**City of Glendale
Community Development Department
Design Review Staff Report – Multi-Family**

Meeting/Decision Date: October 11, 2021	Address: 3419 Montrose Avenue
Review Authority: <input type="checkbox"/> DRB <input checked="" type="checkbox"/> ADR <input type="checkbox"/> HPC <input type="checkbox"/> CC	APN: 5607-004-032
Case Number: PDR2106786	Applicant: Helbert Moradian
Prepared By: Danny Manasserian, Planning Associate	Owner: Arbita Nersesian

The applicant is proposing to construct additions at the front and rear of the existing house, build a new two-story residential unit and garages behind the house, and demolish the existing garage. The property is located in the R-3050 (Moderate Density Residential) zone.

PROPOSD SITE PLAN
1/8"=1'-0"

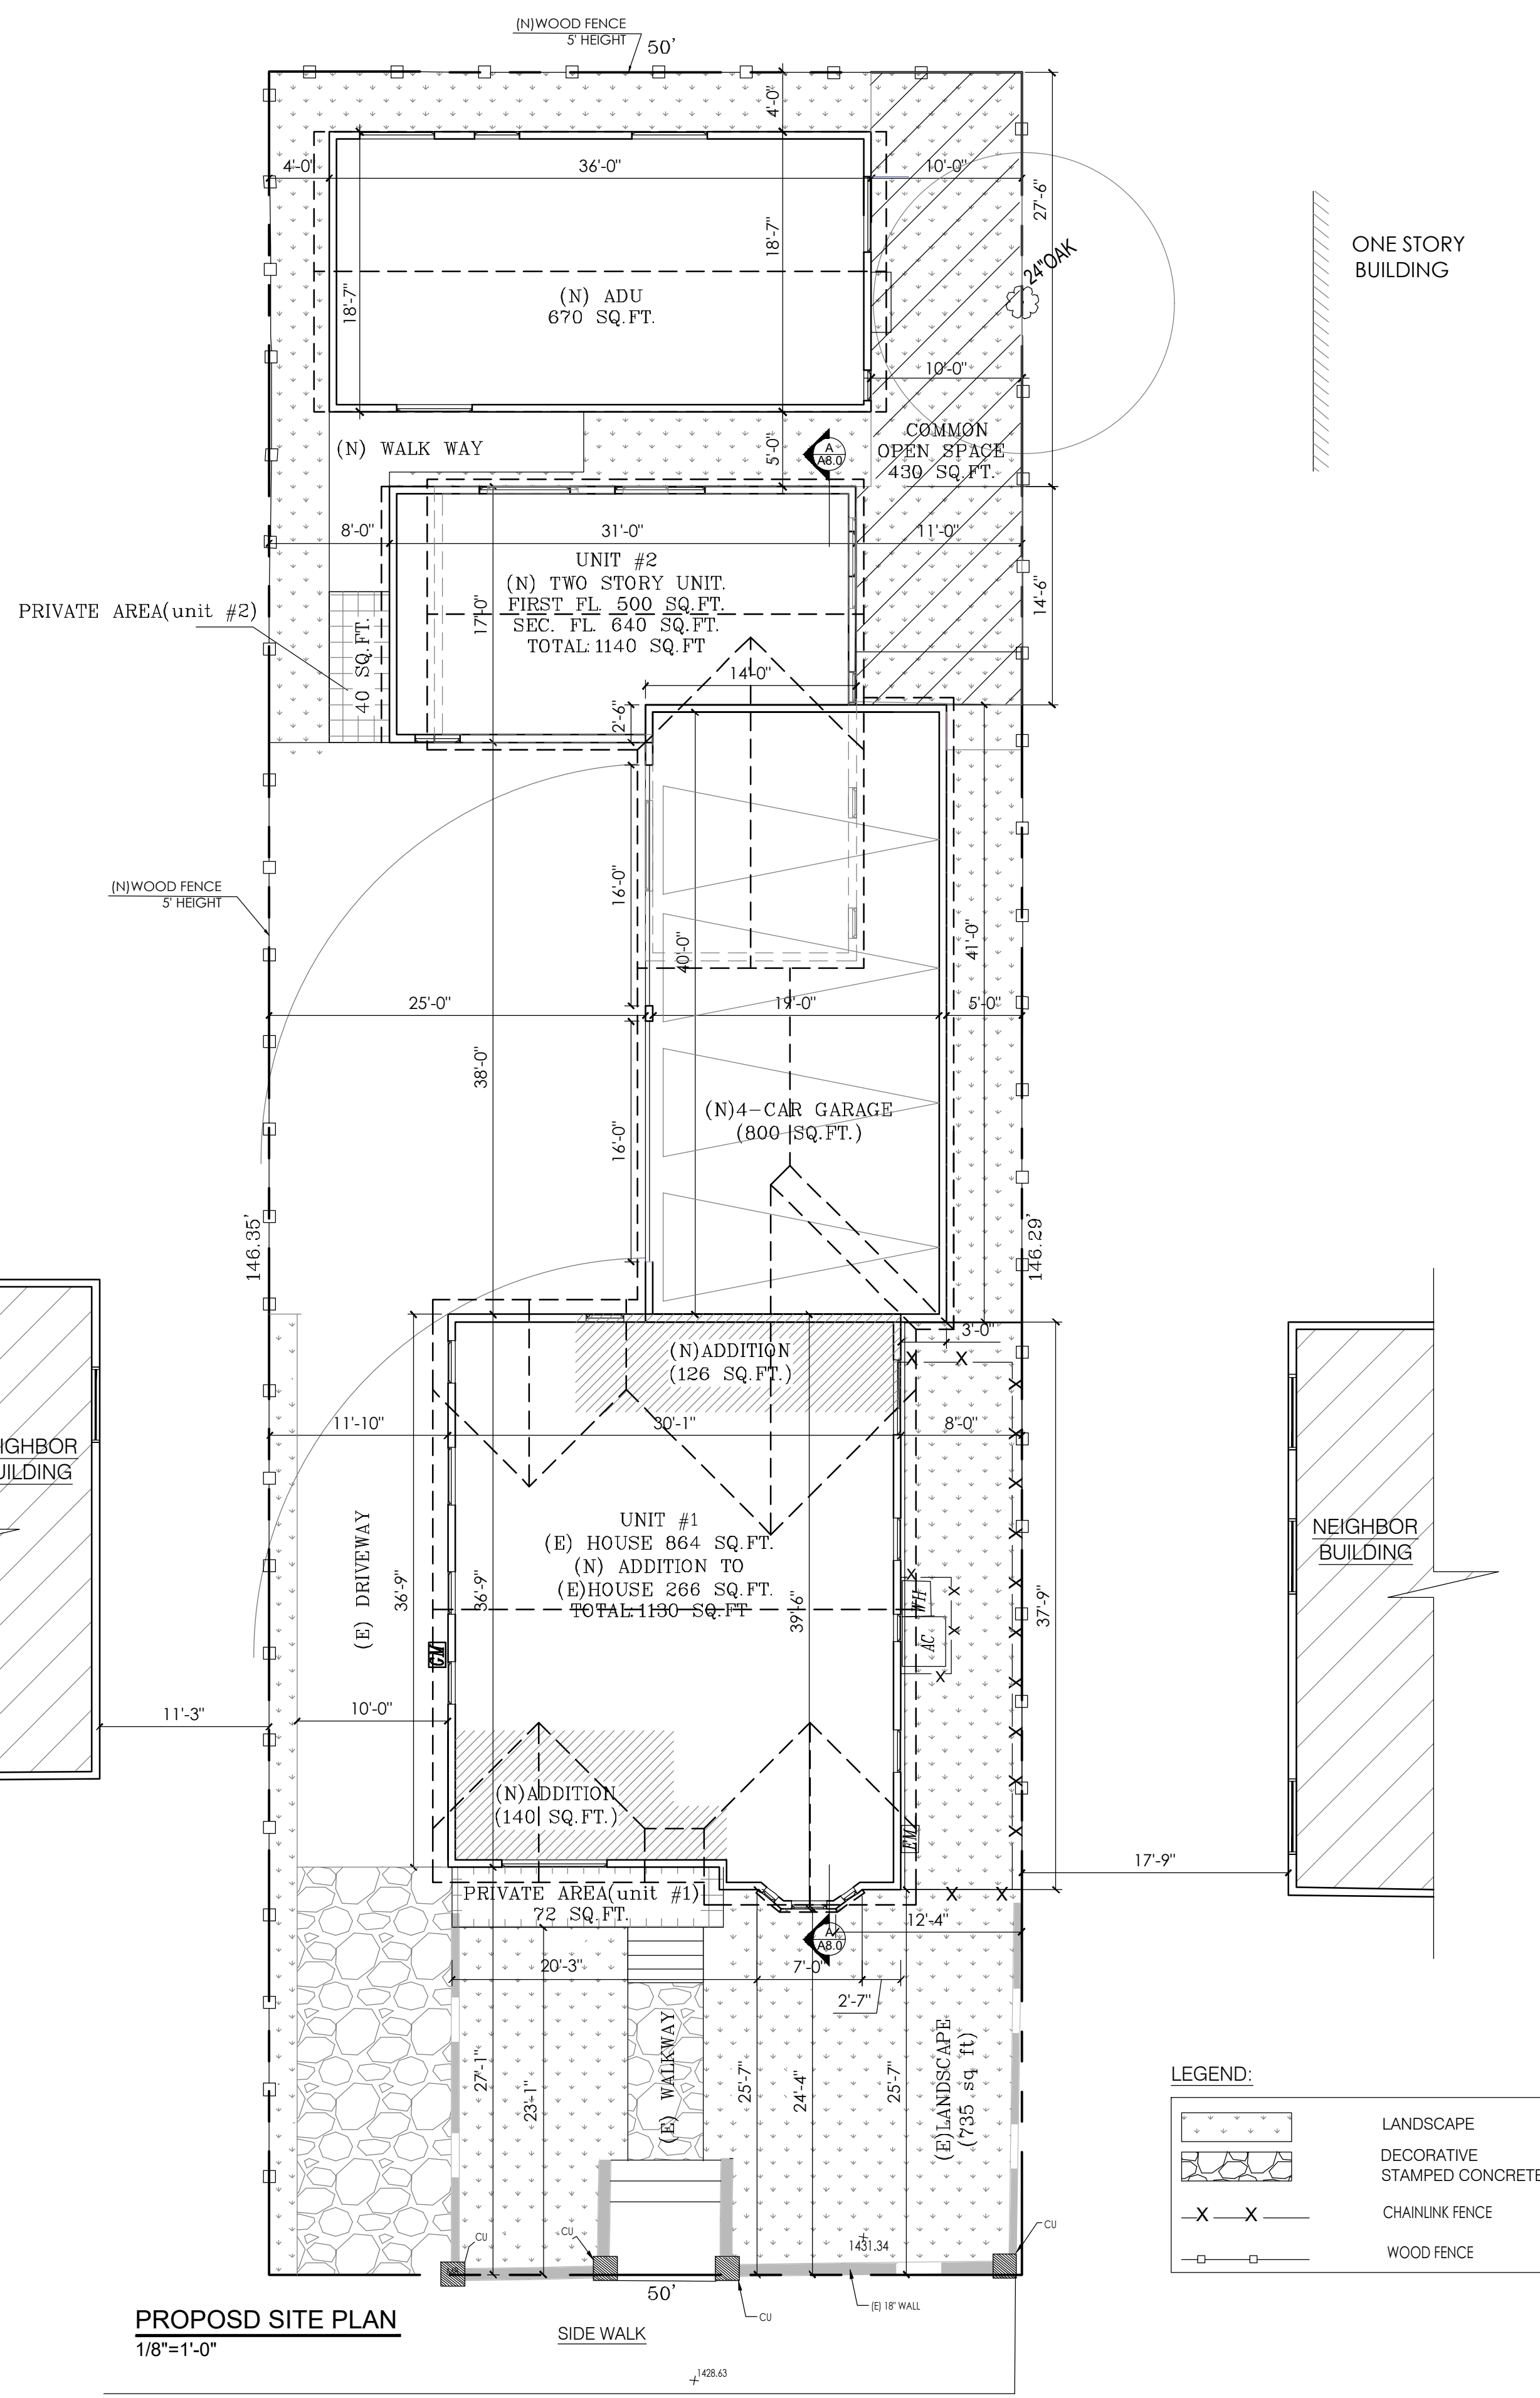
- The building footprint of the existing single-family house will change with the front addition bringing the west side of the house closer to Montrose Avenue (30'-9" existing setback to 27'-1" new street front setback). The existing 24'-4" setback at the east side will remain and the new footprint will not disrupt the prevailing setback pattern.

- The new residential unit and garage is designed with an L-shape building footprint, which is appropriately setback from all property lines to reflect existing neighborhood setbacks.

- Access to the new garage for the existing single-family house and new rear unit will be from the existing driveway located on the west side of the property, which is consistent with the existing site conditions and other properties in the neighborhood.

UNIT ELEVATIONS

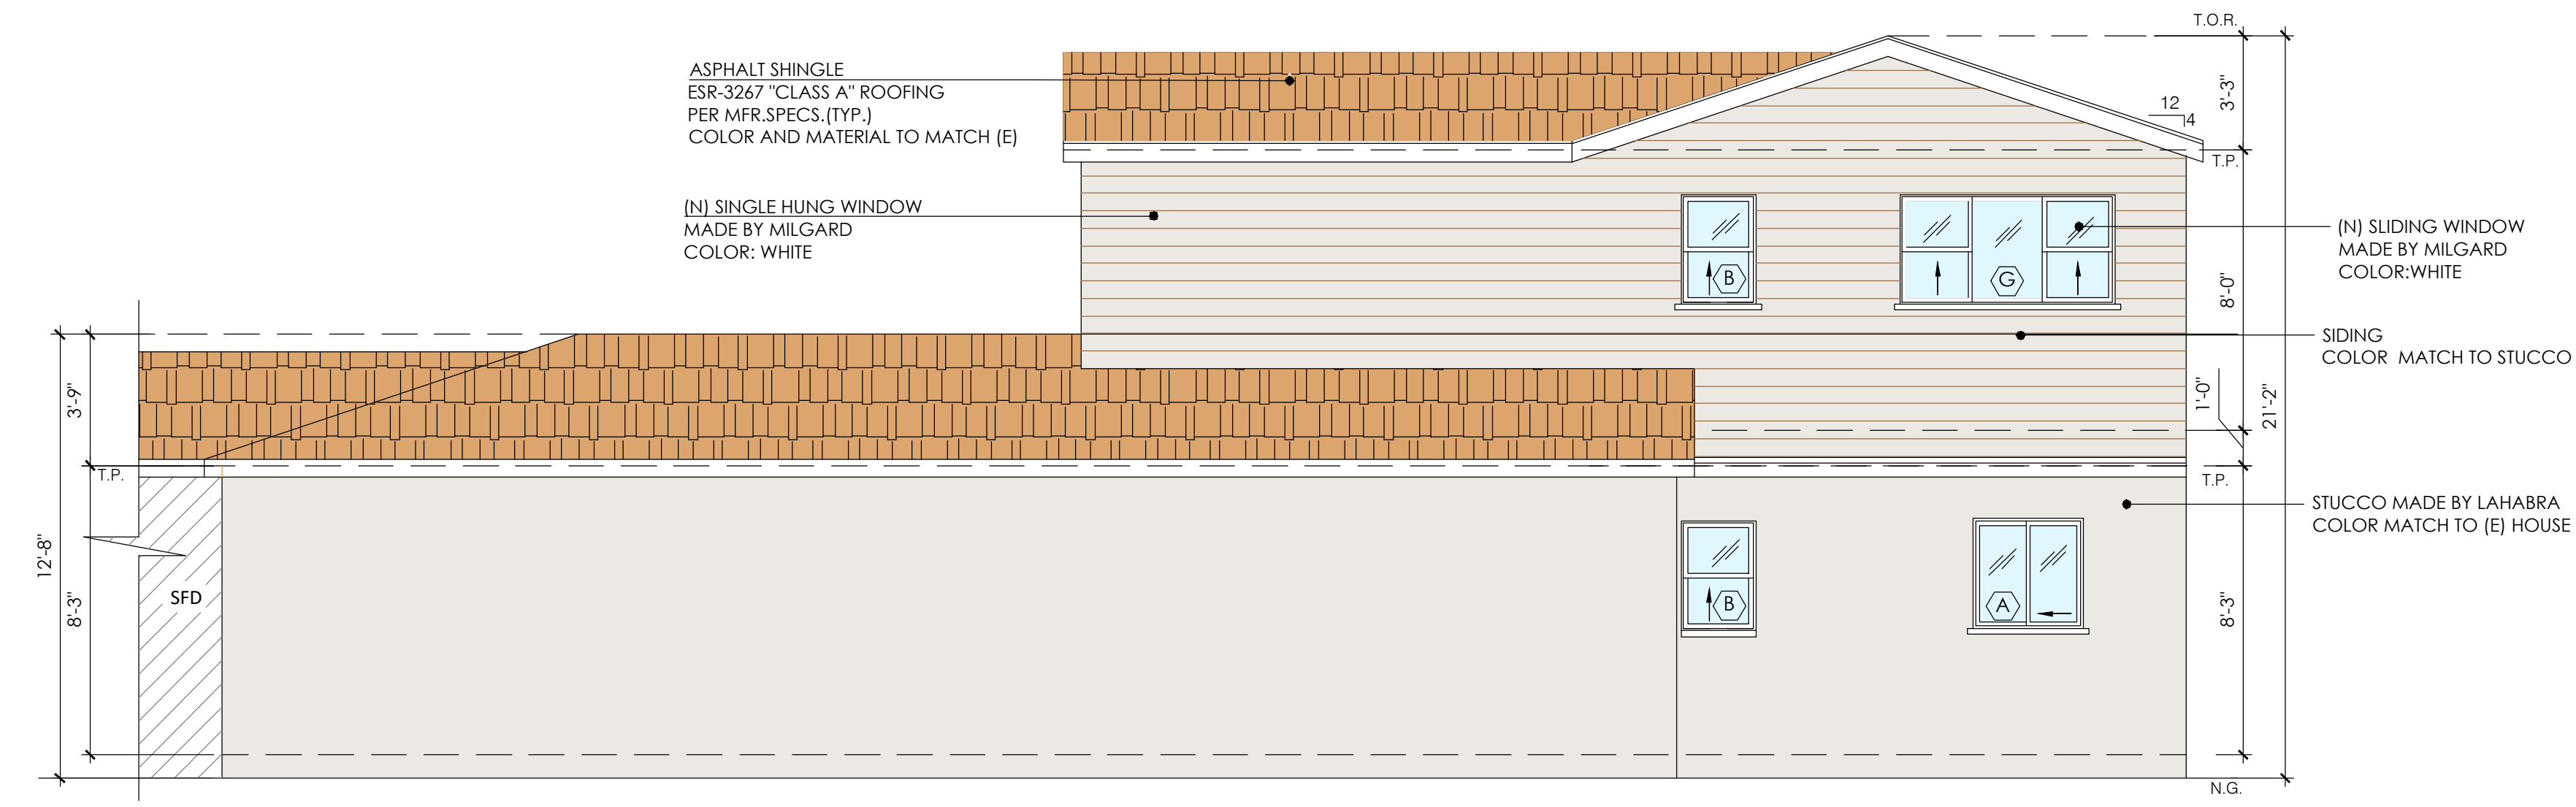
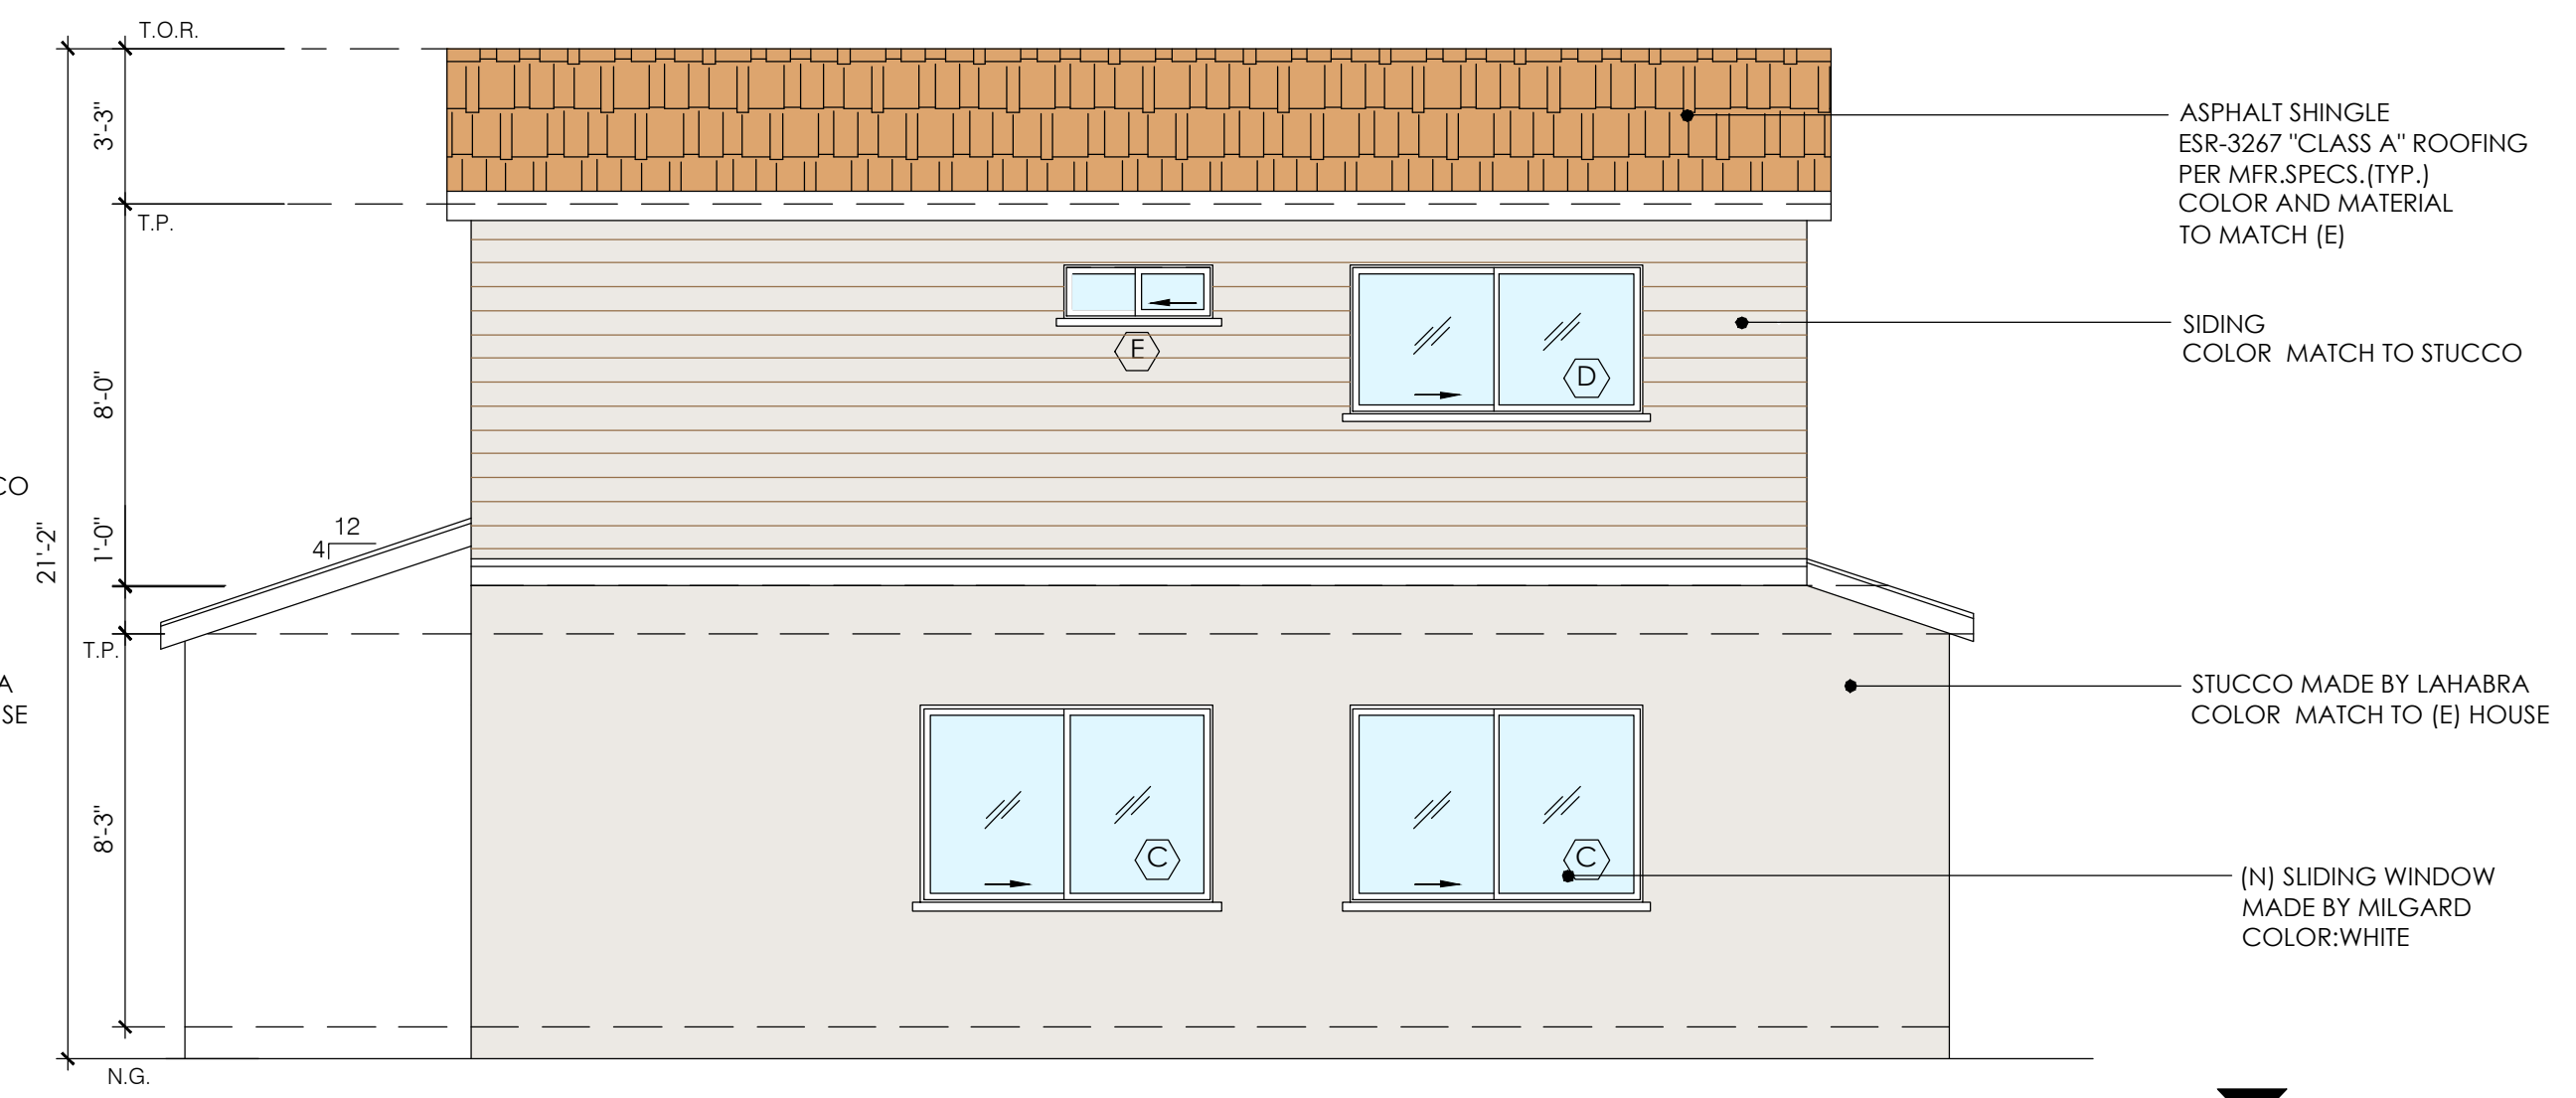
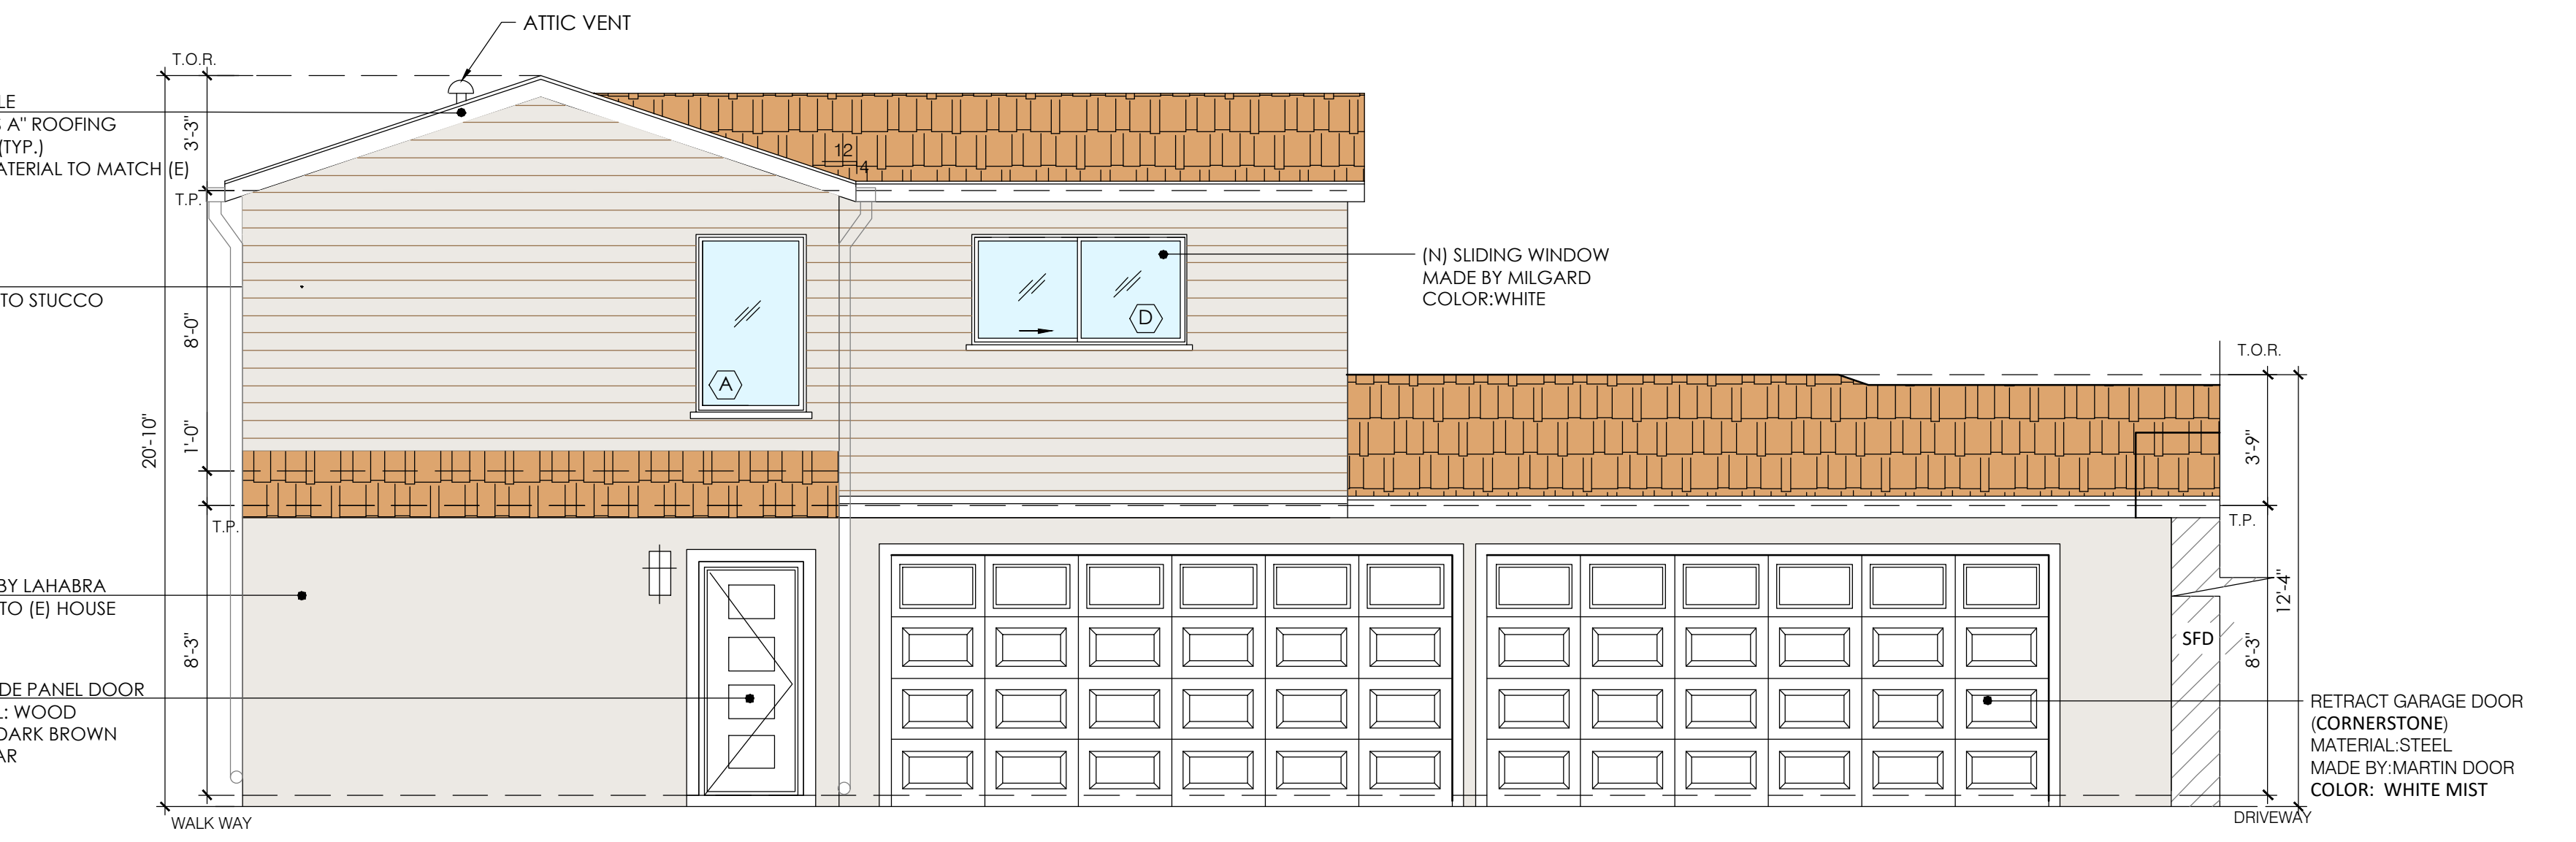
The design will be enhanced if the siding color is somewhat darker, rather than the same as, the color of the walls. A condition to this effect is added.

- The traditional design of the new unit is appropriate to the neighborhood and the existing house.
- The placement of the proposed cement fiber siding on the new unit is appropriate, however, as proposed, the color is the same as the stucco. A condition has been added to choose a somewhat darker color to complement the white stucco.
- All windows will be vinyl, recessed with a wood sill and frame to match the proposed windows on the front house. As proposed, the windows are appropriate to the design and the neighborhood in terms of their operation and overall appearance.
- The roof material includes brown composition shingle, matching the front house.

1. Propose somewhat darker color for cement fiber siding at new unit for staff review.
